Summary of Cost Development Subcommittee Revised Start-Up Cost Package

Tom Hauske
Members Committee
July 27, 2022

Current 2x1 Combined Cycle Unit Start-Up

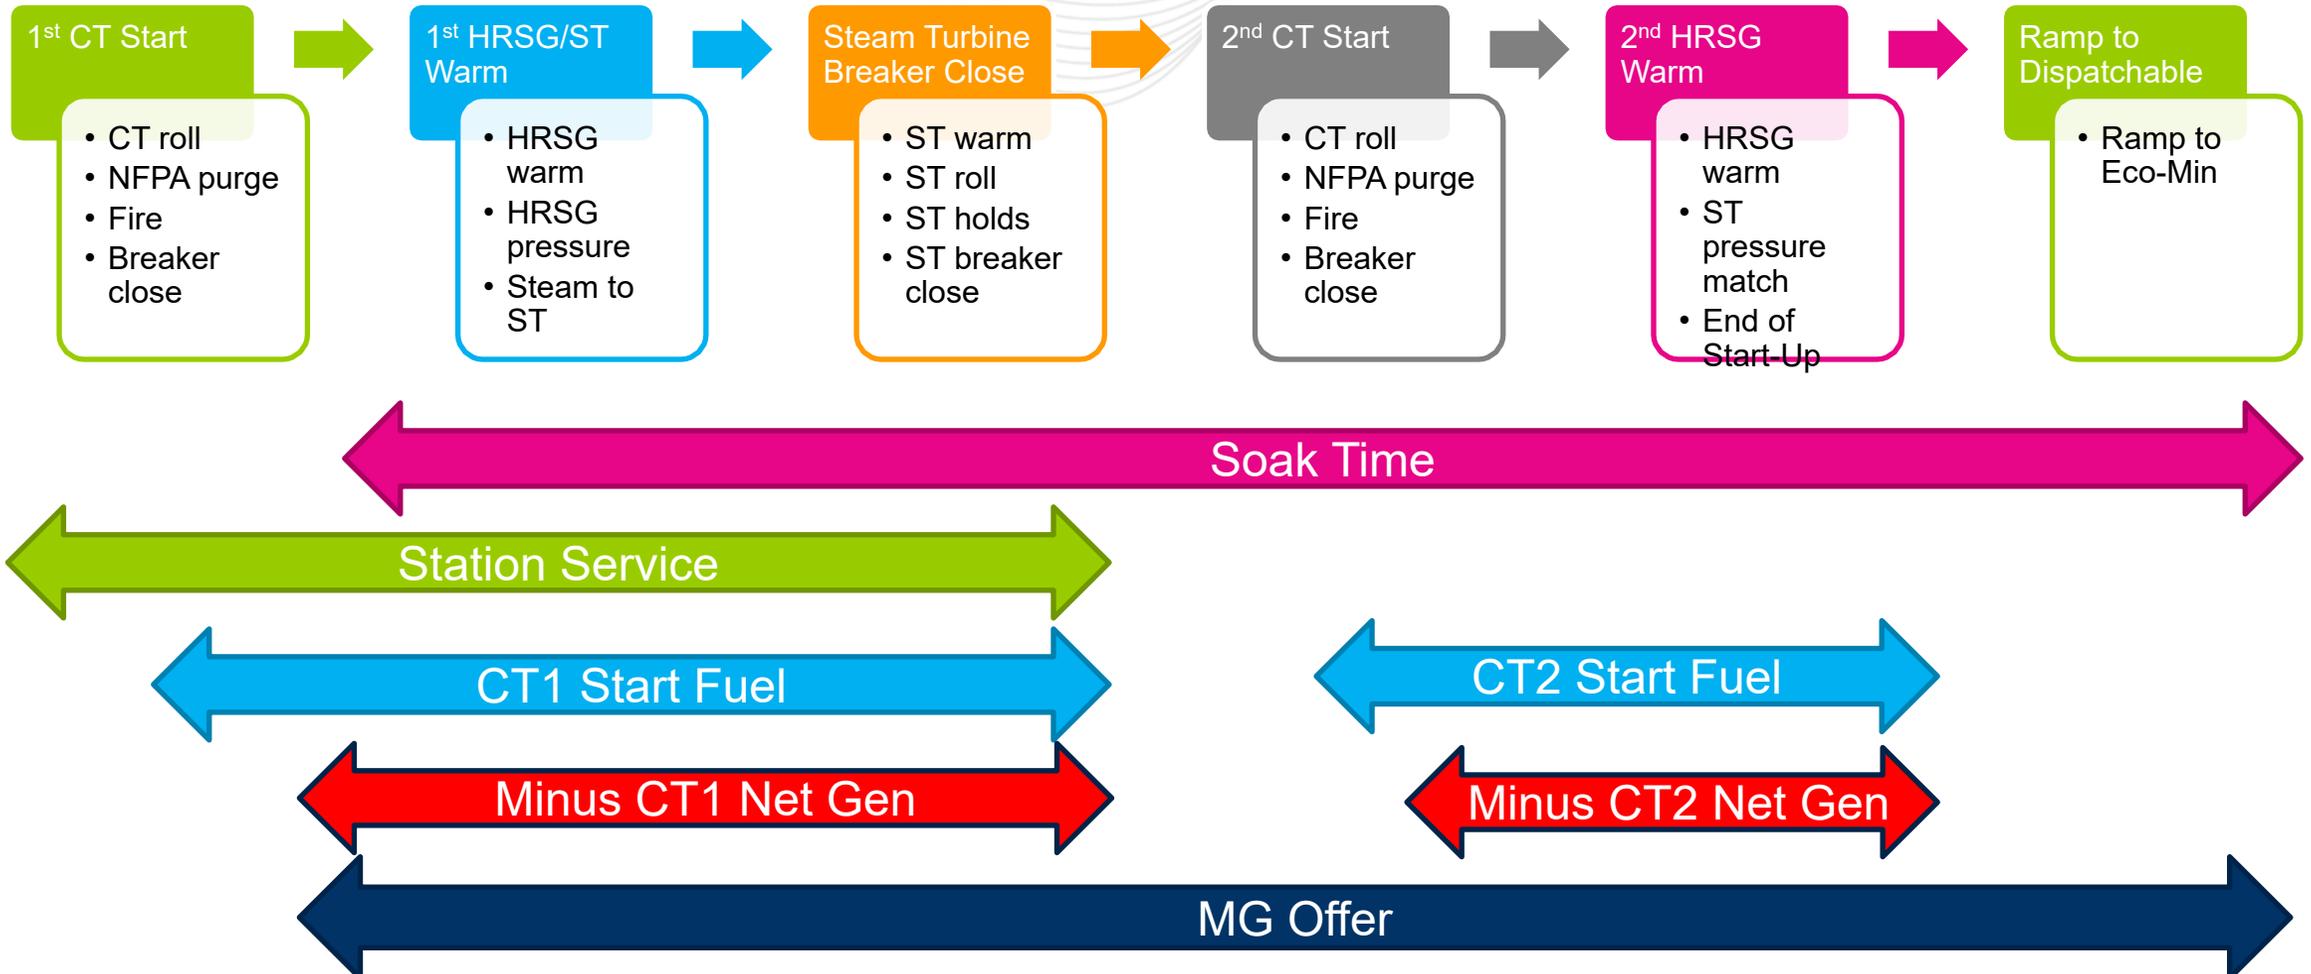
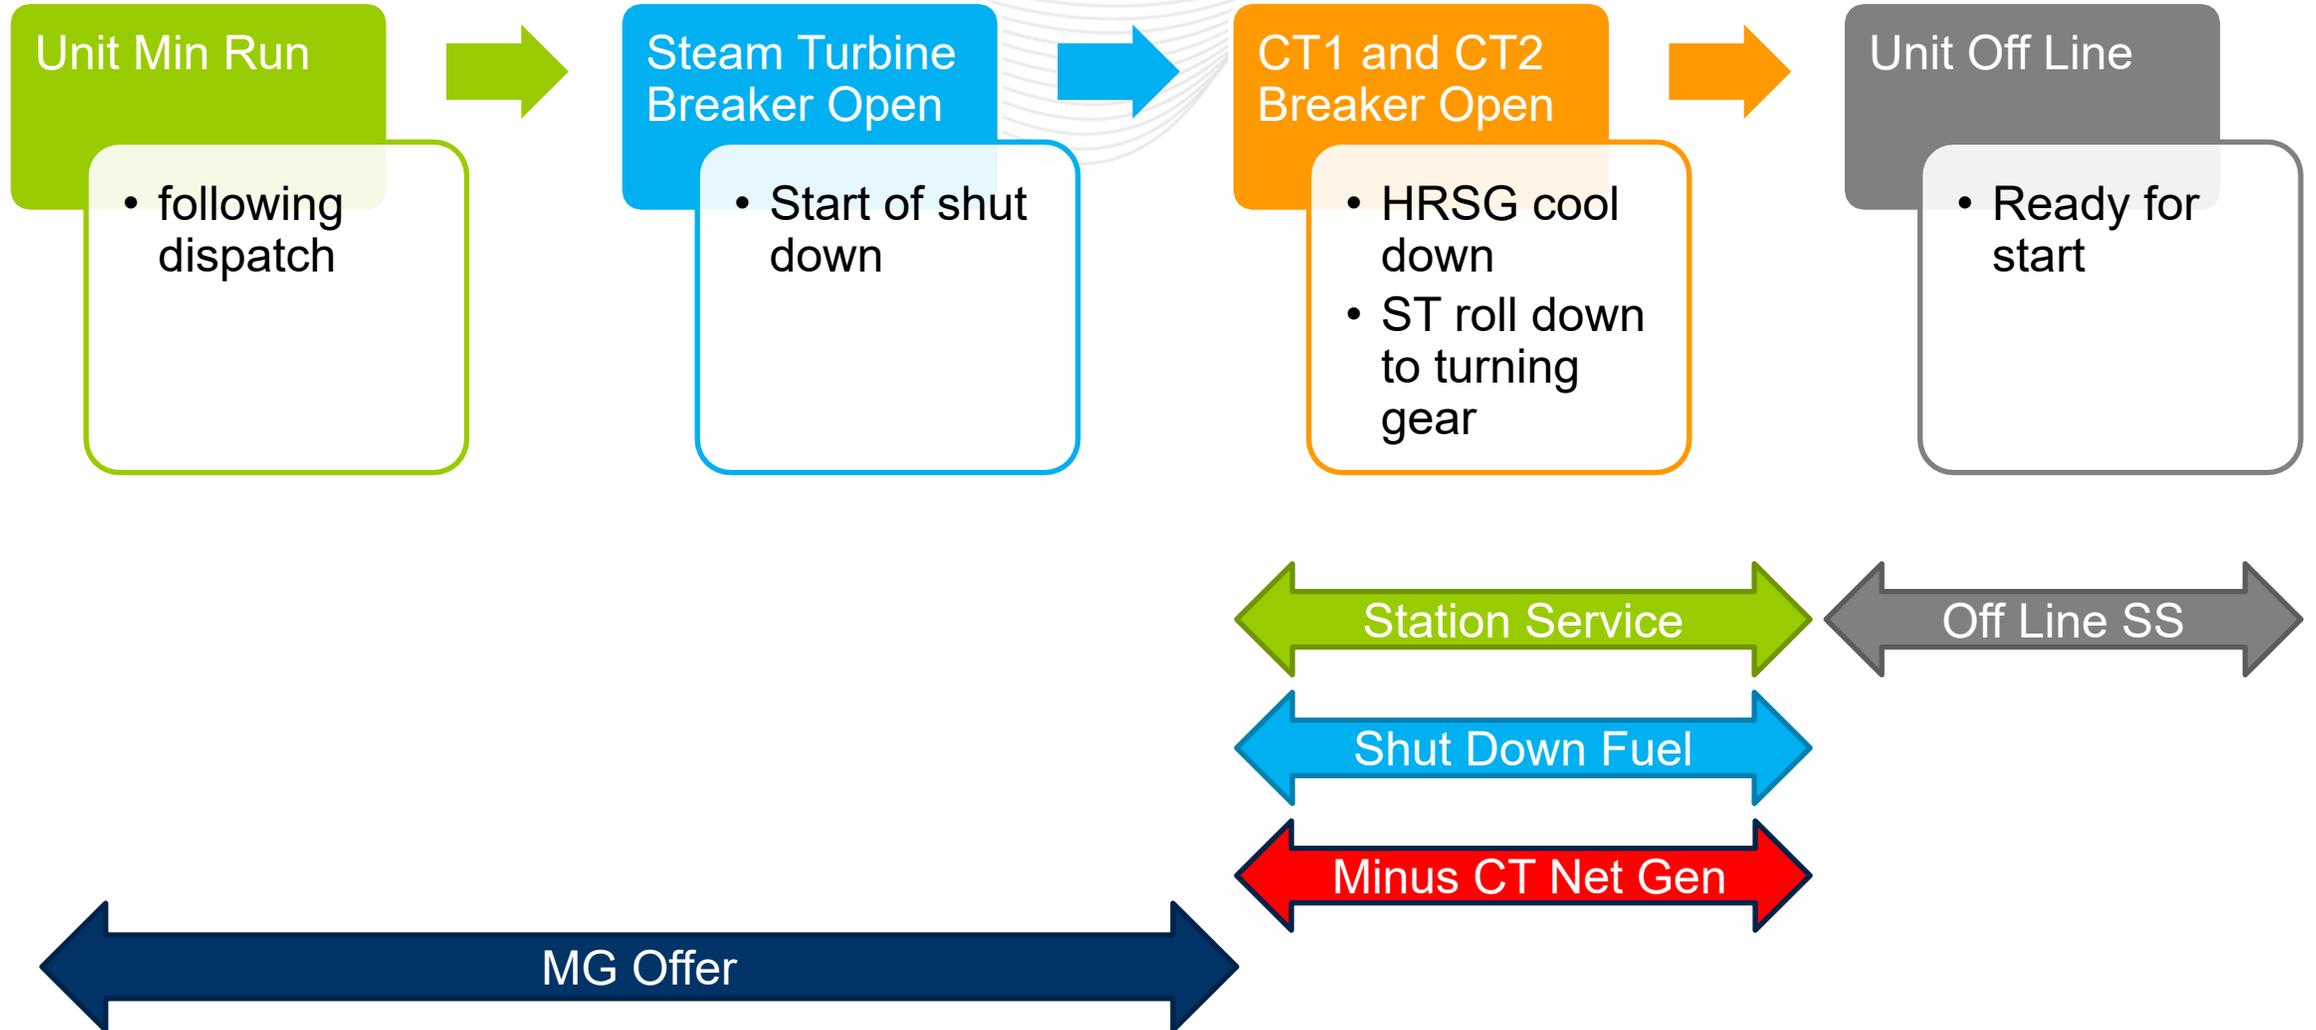
- M15 currently allows combined cycle units to include fuel cost after generator breaker closure and synchronization to the grid in their calculation of Start-Up Costs that other unit types such as steam and nuclear cannot.
- Proposed revisions will align Start-Up Cost all units with a soak process (steam turbines).
- Allow units to include soak cost in Start-Up Cost. Note to avoid double compensation, such units will not be made whole for MWh while soaking.

- The Revised PJM/IMM Package proposes to revise M15 calculations for Start-Up Cost, start fuel and station service to be consistent for all unit types with a soak process (steam turbine) and simplify the calculation of the net generation offset.
